CPCCBC4029B - Practical Task 1 1st Occasion

From: [Melissa Parsons](#)
To: [Chris Dimis](#)
Cc: [Andrew Collyer](#); [Daniel Ogden](#)
Subject: 70 The Strand | Kitchen Drawing RFI"s
Date: Friday, 14 May 2021 1:01:37 PM
Attachments: [facebook_logo@2x_26508827-e760-4f91-af51-7276851ce991.png](#)
[instagram_logo@2x_af1f28be-4495-436e-9a55-2af51774bcdd.png](#)
[linkedin_logo@2x_a7c89ab1-b2a6-4030-99d3-0f09422a2e81.png](#)
[RCQlogo_d039a935-3f1d-4532-80a4-3227b78e5fd9.png](#)

PROJECT:
70 THE STRAND

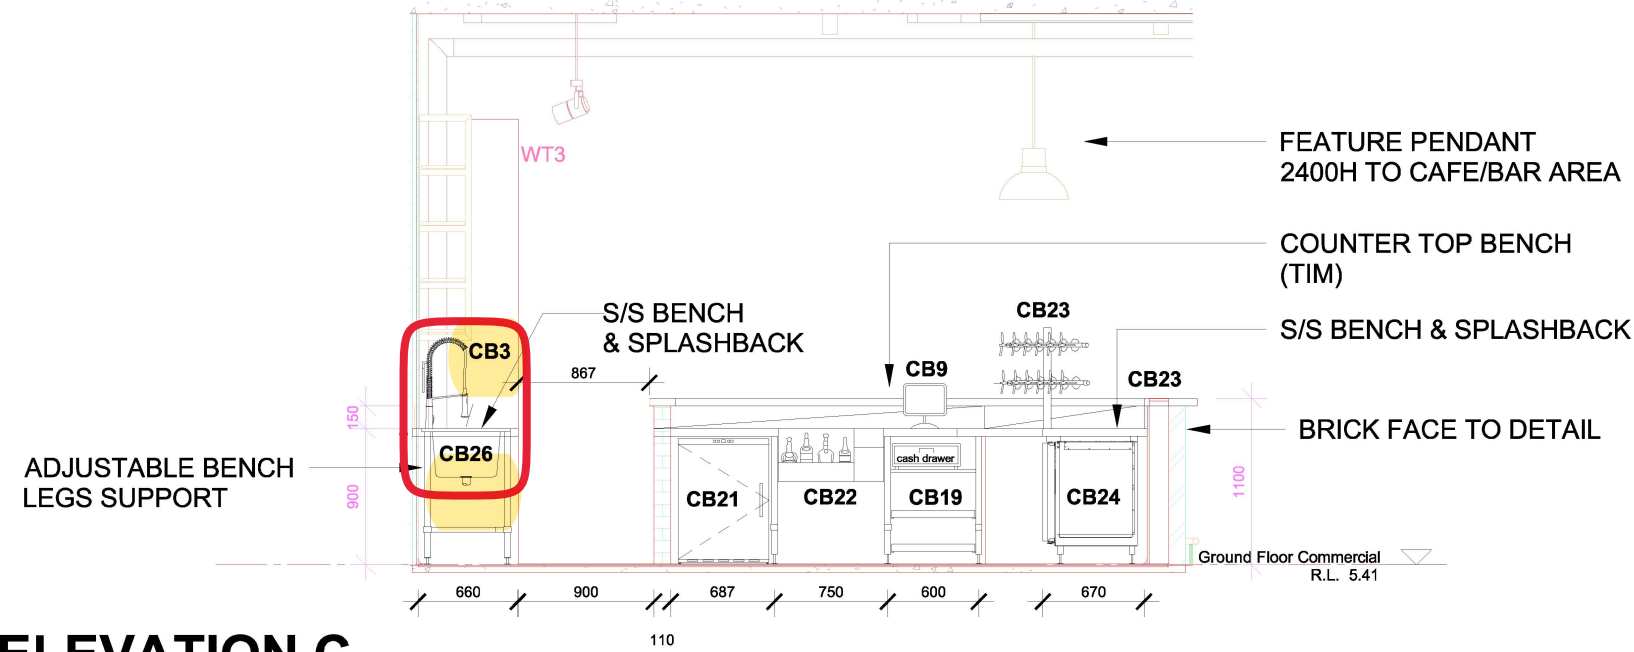
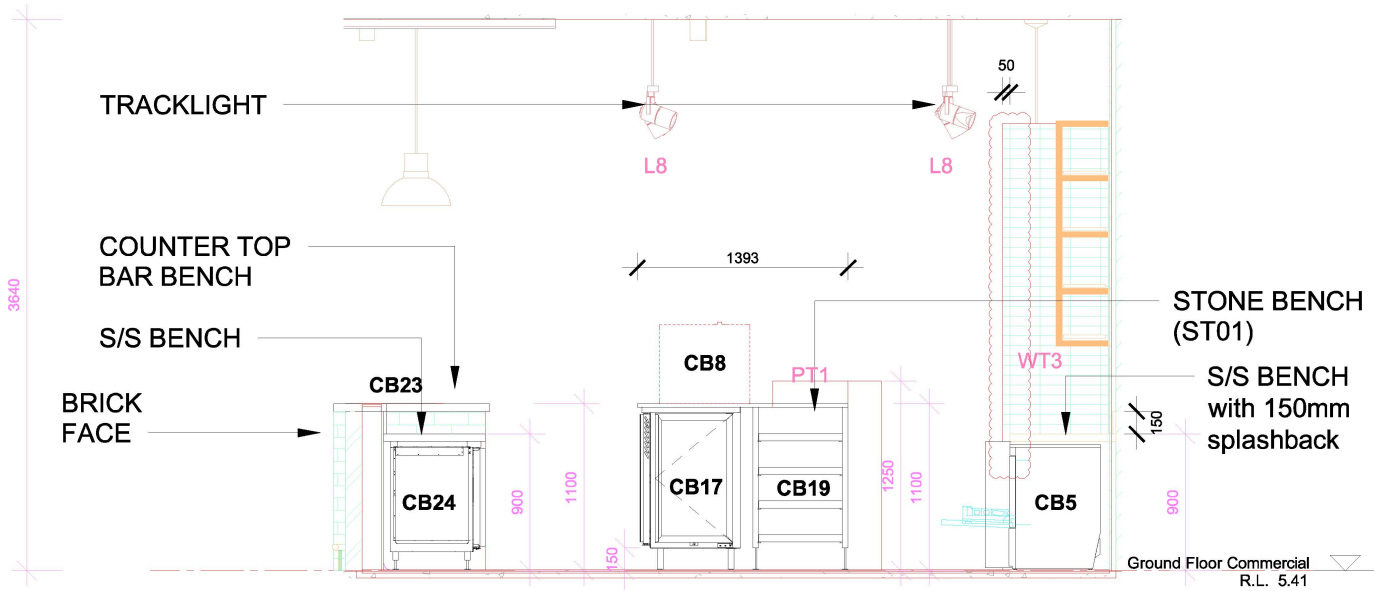
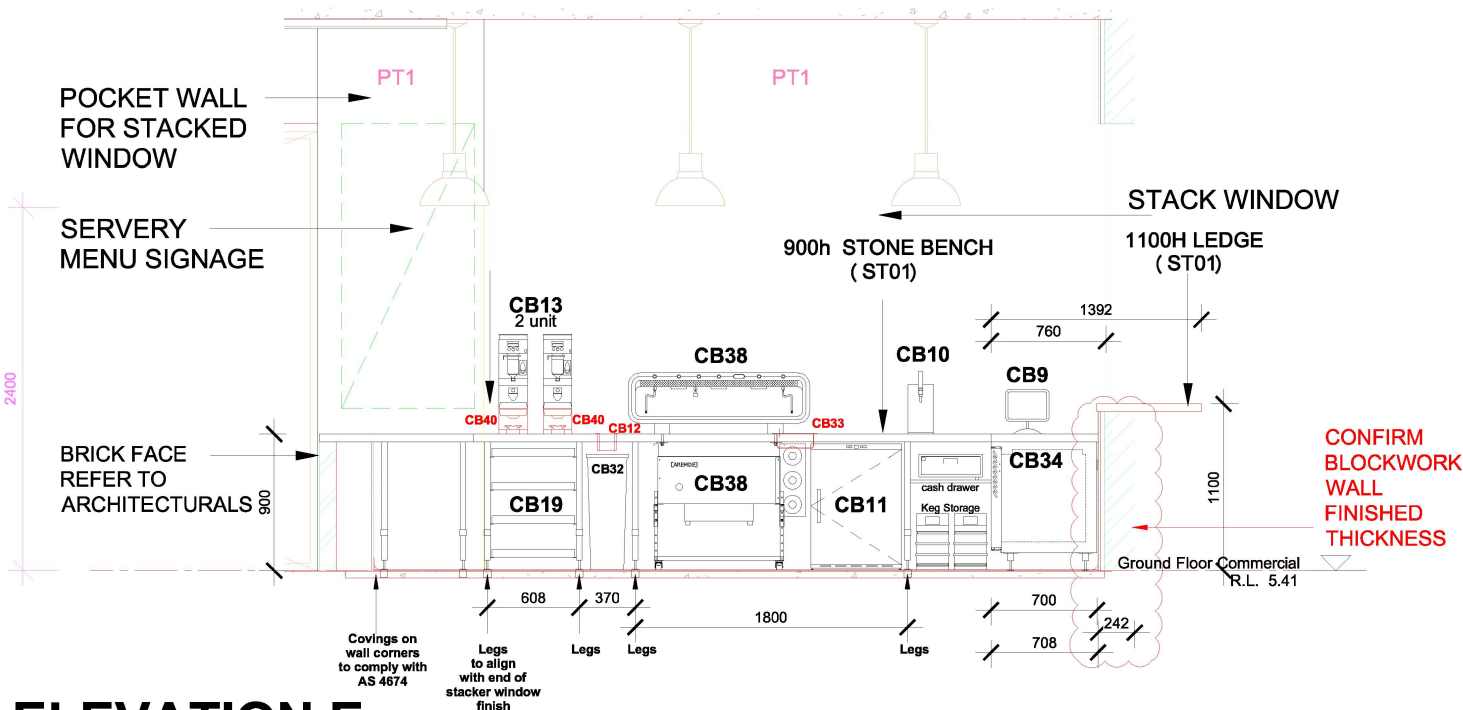
CB3 (sink) & CB26 (tap) are not that clear

Schedule CB3 is a sink and CB26 is a tap
CB01 INT1 Rev 8 – they match the schedule
CB01 INT3 Rev 8 - they are reverses, so tap is CB3 and sink CB26
CB01 INT2 Rev 8 - match the schedule CB3 sink and CB26 tap

Can you please confirm which way it is and update the incorrect drawings and send back to me ASAP

Great pickup on the details. Alex has updated the drawing and changed over the labels, please find attached.

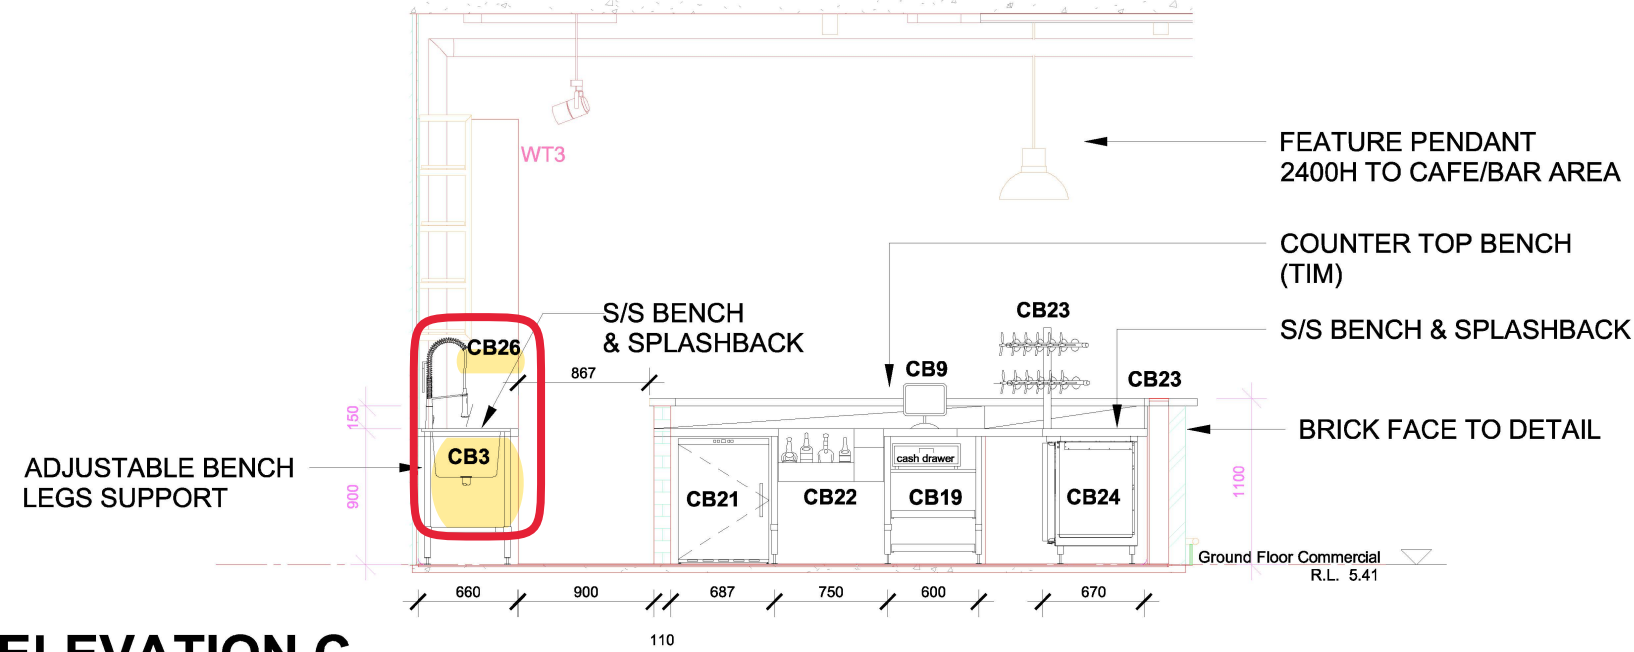
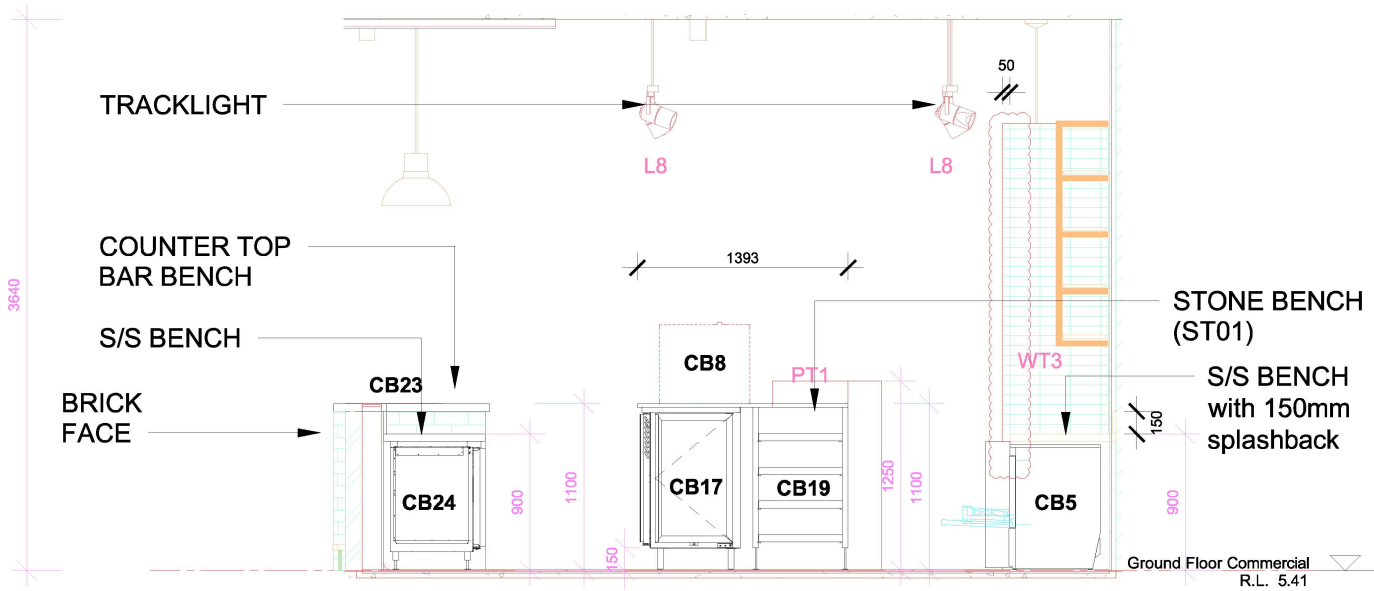
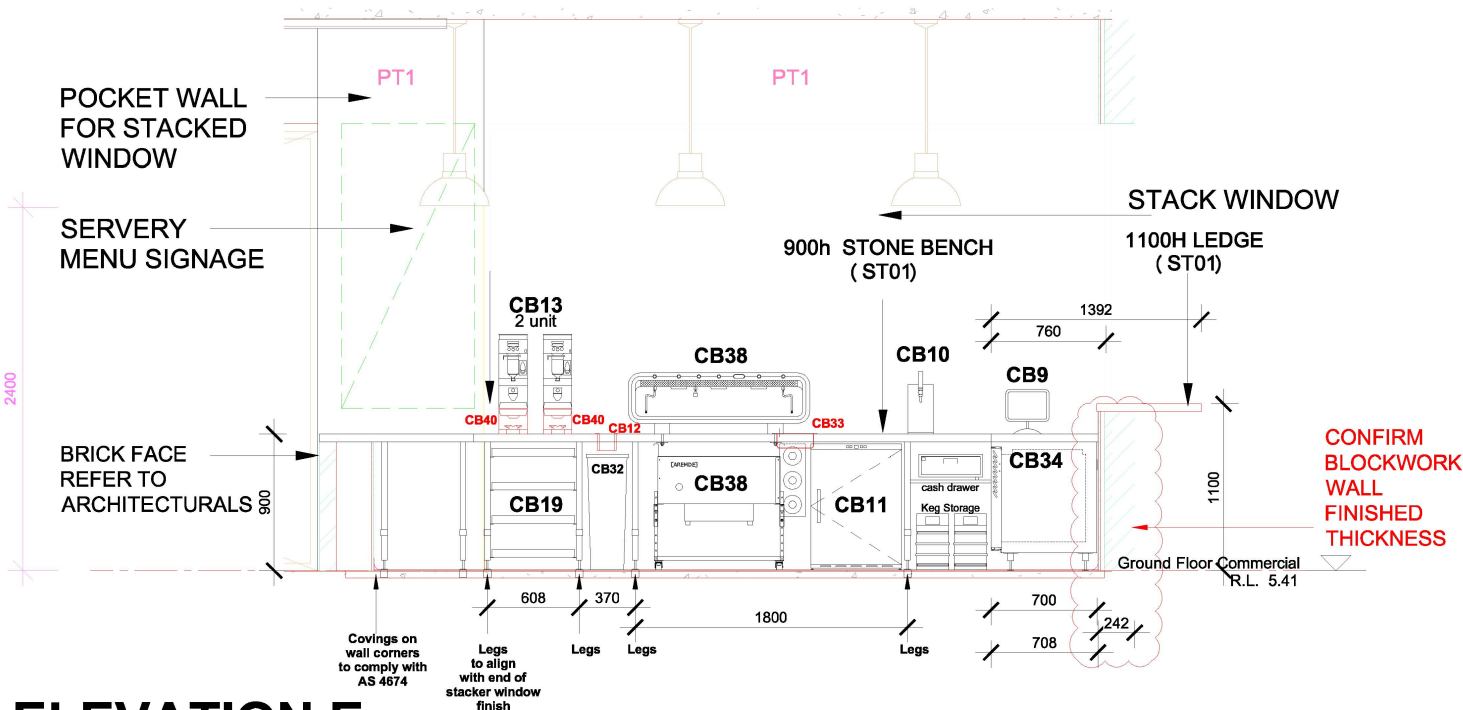
CB3 (sink) & CB26 (tap) are not that clear

Schedule CB3 is a sink and CB26 is a tap
CB01 INT1 Rev 8 – they match the schedule
CB01 INT3 Rev 8 - they are reverses, so tap is CB3 and sink CB26
CB01 INT2 Rev 8 - match the schedule CB3 sink and CB26 tap
